DAC3 upgrading Pavane – Check your Pavane Level

To upgrade to DAC3, a Pavane needs to be Level 2 or Level 3. A Level 1 Pavane can be sent back to our factory for modification to accept DAC3. The modification is two-fold:

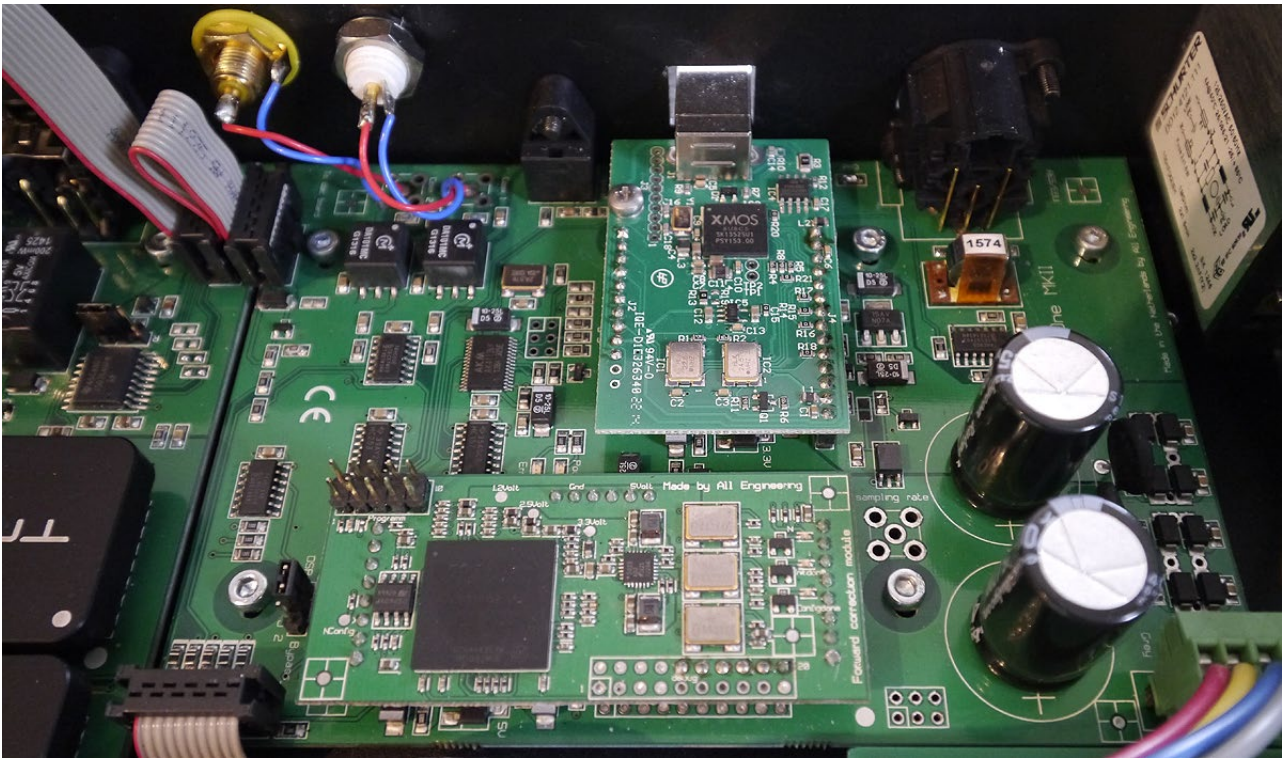
- The DAC boards need to be modified so the data enters the DAC module correctly
- If you want to be able to place an MQA module later, the Digital input board needs to be exchanged as well

The digital input board shows the difference; it has the forward correction module on it. Also, the DAC modules are DACone.
